# Access Compliance Report

## Public Rights-of-Way

### (Pedestrian Signals)

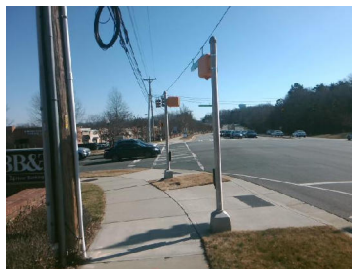
Intersection ID: N/A	Main Street:	Cross Street: N/A	Location: N/A
ADA ID: E4D26C89133C	Signal Type: One Push Button-APS	Overall Compliance: No	Severity Score: BTN 1: N/A BTN 2: N/A No BTN: N/A
Codes/Mitigation Info/Possible Solution		Field Measurements/Component Compliance

N/A	B 1 Clear Xing Direction?	Yes	N/A	B 2 Clear Xing Direction?	N/A
	B 1 Crossing Direction	To S		B 2 Crossing Direction	N/A
Yes	B 1 DistanceTo XWalk (in)	28.0	N/A	B 2 DistanceTo XWalk (in)	N/A
No	B 1 DistanceTo Curb (in)	76.0	N/A	B 2 DistanceTo Curb (in)	N/A
Yes	B 1 Diameter (in)	2.0	N/A	B 2 Diameter (in)	N/A

Possible Solutions: Replace Signal Push Button With APS Button on New Post. Remove & Replace Sign.
